SUBJECT: NRC OBSERVATIONAL SITE VISIT AT THE MEXICAN HAT, UTAH
DISPOSAL SITE 2018-001

Report: WM-00063/2018-001

Facility: Mexican Hat Disposal Site

Figure 1: Site marker on top of Mexican Hat disposal cell

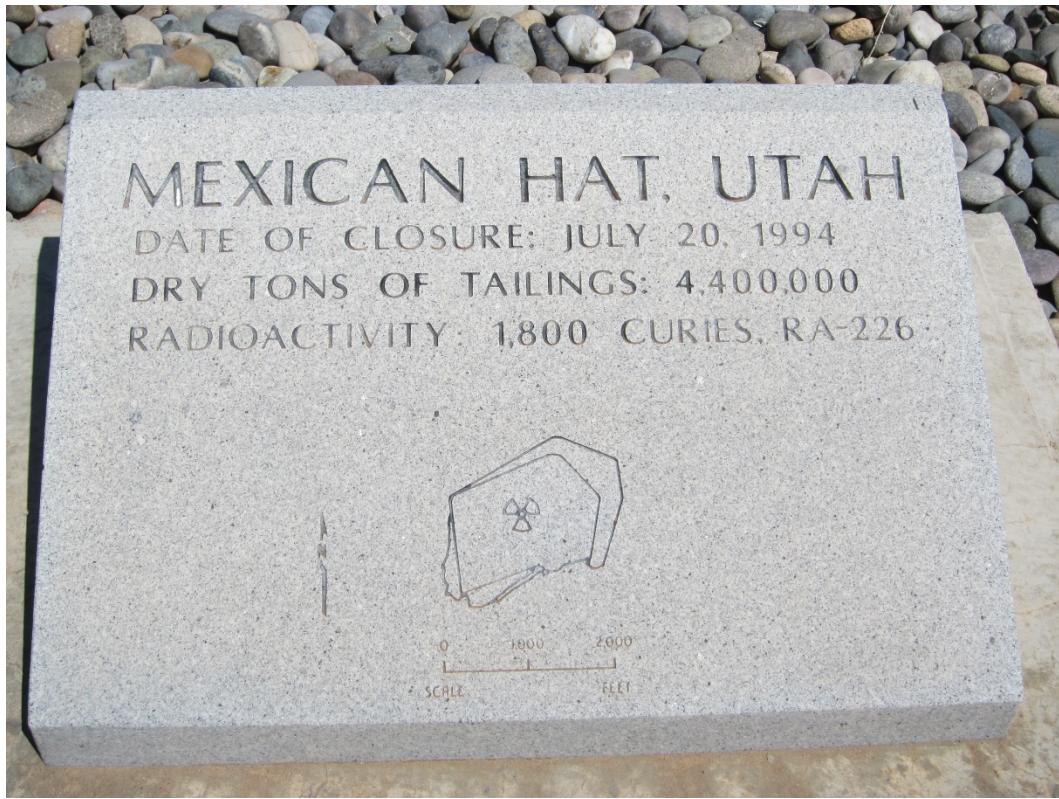
The site consists of a disposal cell located within a fenced boundary. The disposal cell was constructed with a rip-rap layer, bedding layer, and radon barrier over the contaminated materials. The DOE installed 43 warning signs and 12 boundary markers around the disposal cell. The DOE also installed two site markers on the site property. One marker was installed on top of the cell, and the second marker was installed adjacent to the main gate.
